Memorandum

FROM : Hilbert W. Crocker, Inspection Specialist (Criticality)
Region III, Division of Compliance, Chicago

SUBJECT: PART 70 INSPECTION, WESTINGHOUSE ELECTRIC CORPORATION, PITTSBURGH,
PENNSYLVANIA - LICENSE NO. SNM-338 (DOCKET NO. 70-337)
INSPECTION DATE: APRIL 29-30, 1965

Figure 1
Vault 4-a
Scale: 1" = 4'-0"
6-8-62

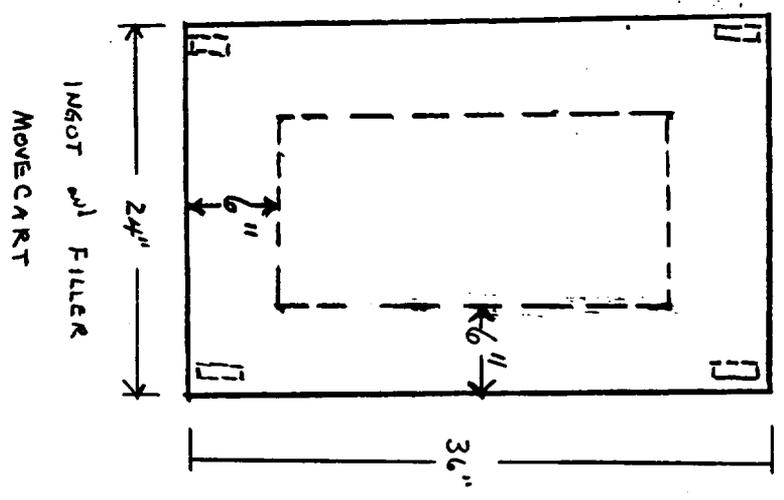
Comment 1. Please submit solid angle calculations for Vault 4-a.

The following solid angle calculations for deriving a fast neutron surface density limit will be used to show the array in Vault 4-a:

Figure 2
ATTN. Movecarts
Scale 1"=4'-0"
U-8-62

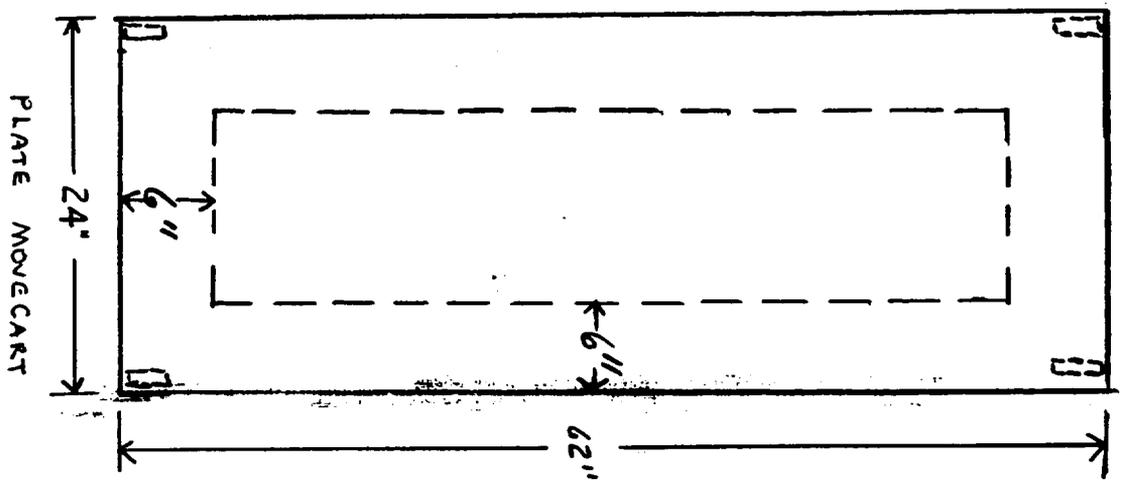
Comment 2. Please confirm that mass control will be used on all ingot, filler and plate movecarts instead of the planar concept.

Mass control is used in the highly enriched storage rack, Figure (2), (3), and (4). Each part is 4" x 6" x 6". A 6-inch diameter sphere is assumed for interaction calculations (See Fig. 1).

Figure 2

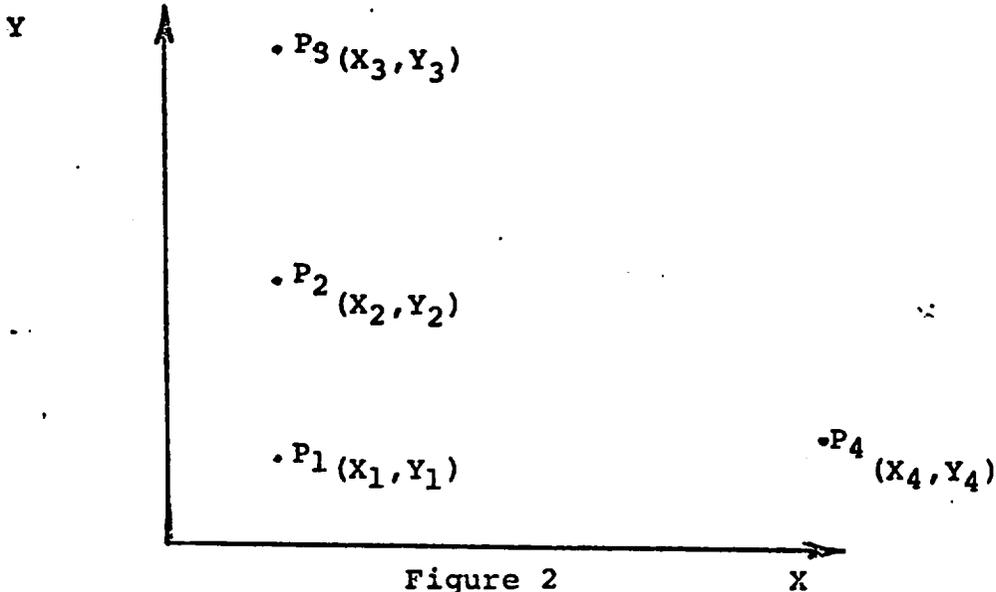
Our concern arose from the situation diagrammed in Figure 2.

Examination of this figure demonstrates that since P_1 , P_2 and P_3 are in a line, $X_1 = X_2 = X_3$ and the quantities $X_2 - X_1$ and $X_3 - X_2$ are equal to zero. Therefore, no exclusion area would be permitted. A statement that permits such a condition is obviously erroneous. Similarly, $Y_4 - Y_1$, is very small, so that although the points are widely separated, they would drastically limit the exclusion area available around each point. This also is unrealistic.

Westinghouse has modified the proposed license condition to provide for these conditions, which are particularly prevalent in the PFDL where operations are carried out in glove box lines.

Figure 3

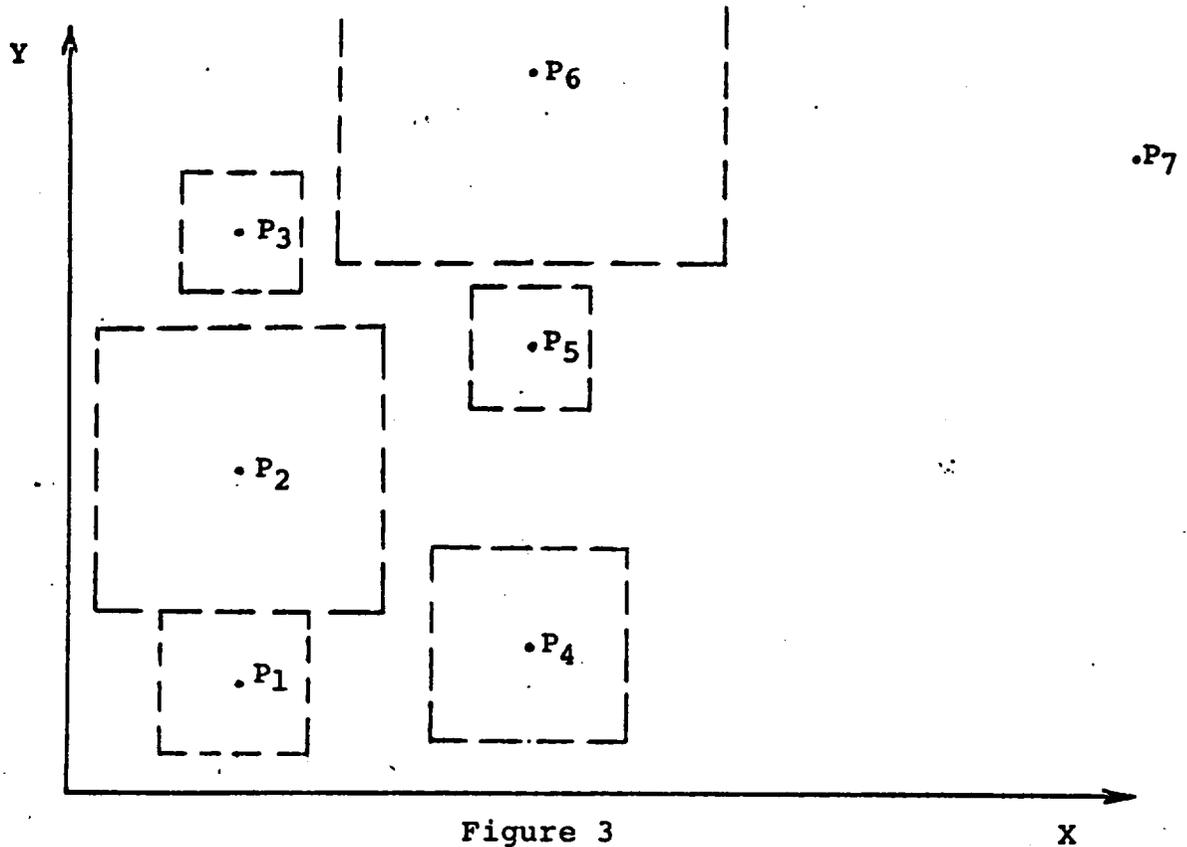
Assuming an arrangement similar to that in Figure 2, Westinghouse would provide exclusion as shown in Figure 3.

Thus Line 1, containing P₁, P₂ and P₃ in a linear array and Line 2, containing P₄, P₅ and P₆ in a separate linear array would be spaced based on center-to-center distances within the individual lines. The only requirement would be assurance that none of the areas "assigned" to one line overlaps an area reserved for the other. P₇ would be considered separately, and would not be evaluated relative to either P₃ or P₆.

FIGURE 9.2.2

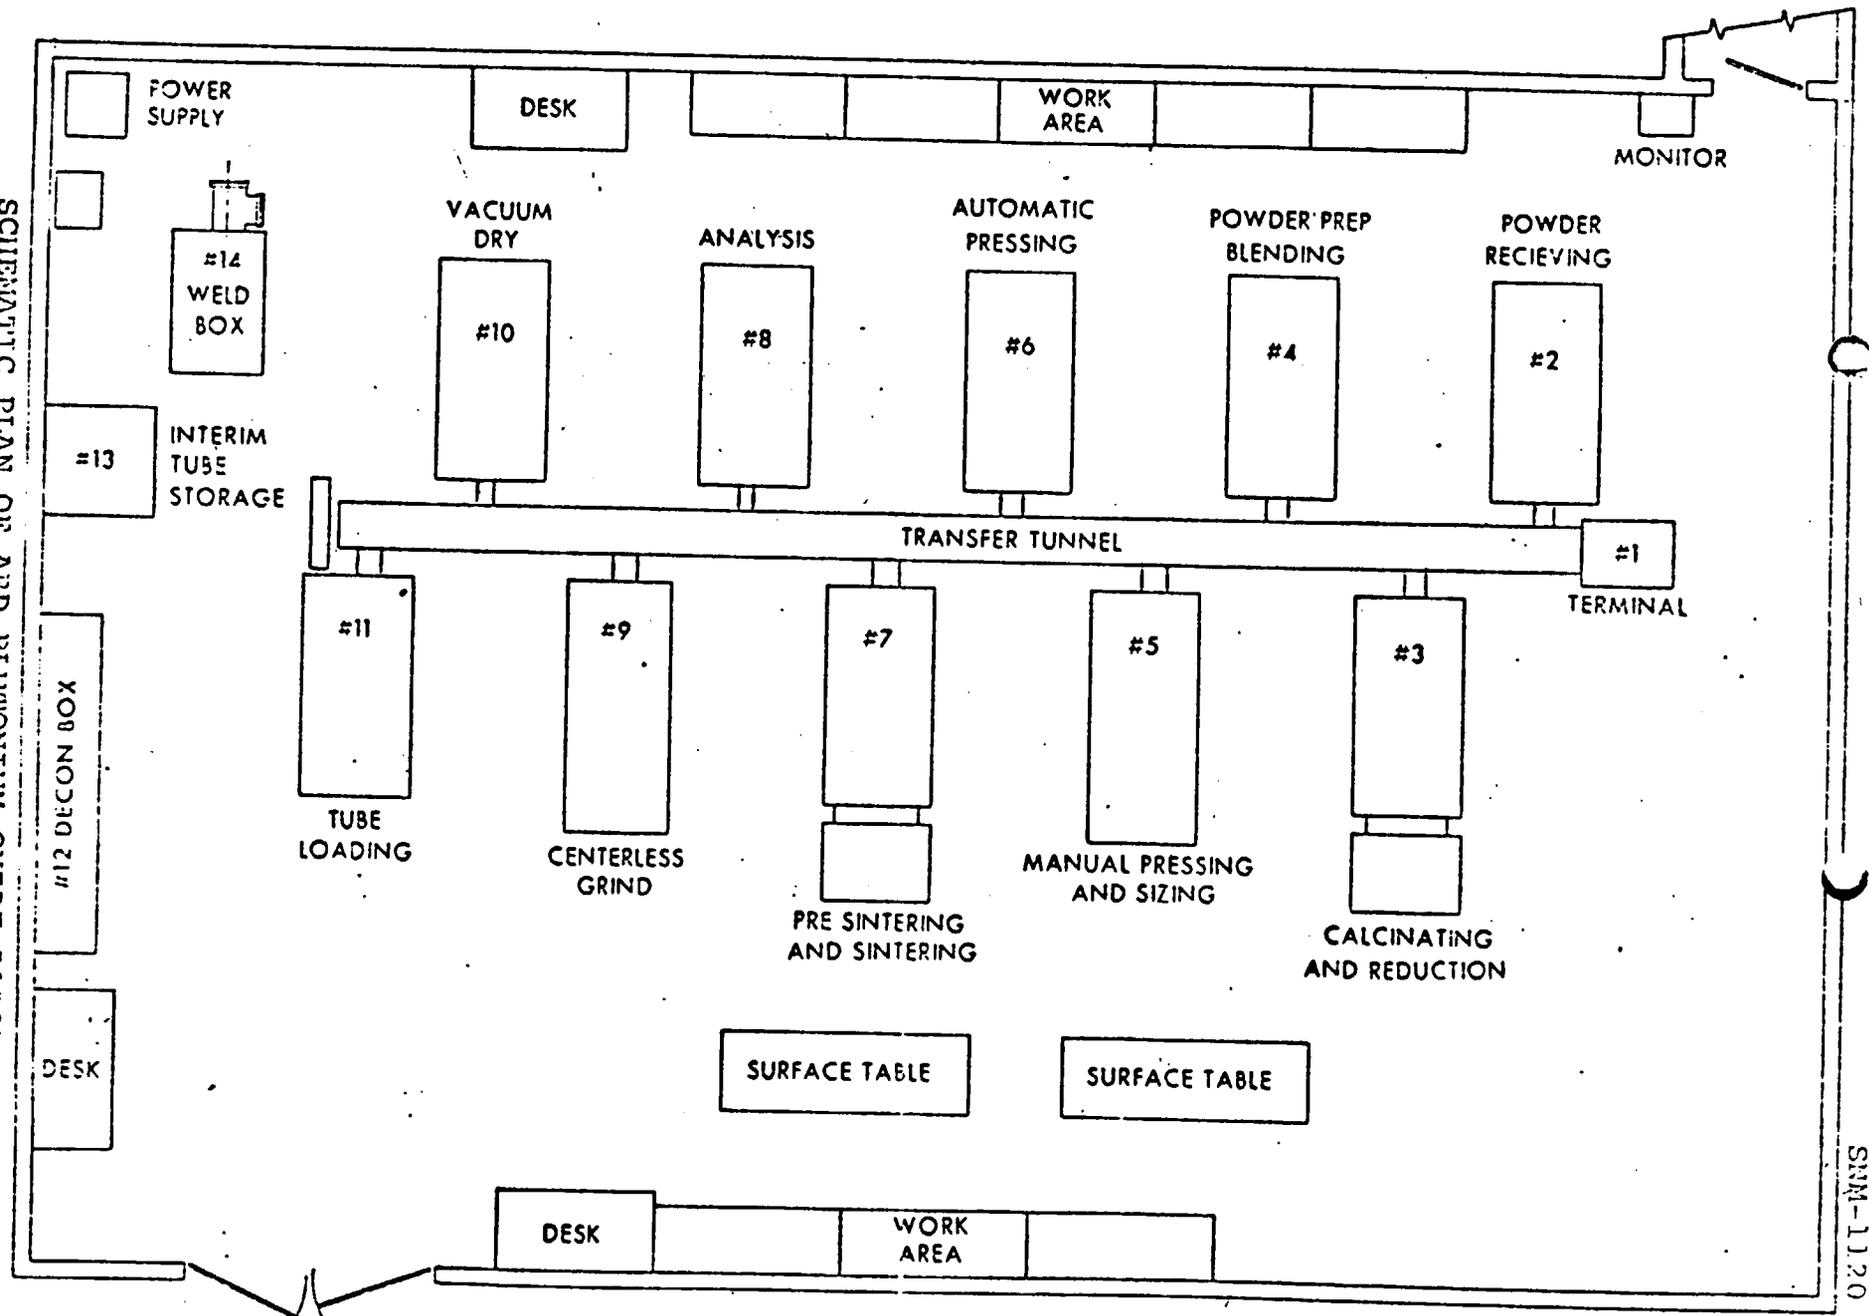
A practical application of this approach is demonstrated in the attached Figure 9.2.2 taken from the application. Obviously, the spacing considerations for Boxes #2, #4, #6, #8 and #10 should not be restricted because Boxes #3, #5, #7 and #9 are spaced directly in the gaps between them, when the odd-numbered boxes lie on the other side of the transfer tunnel.
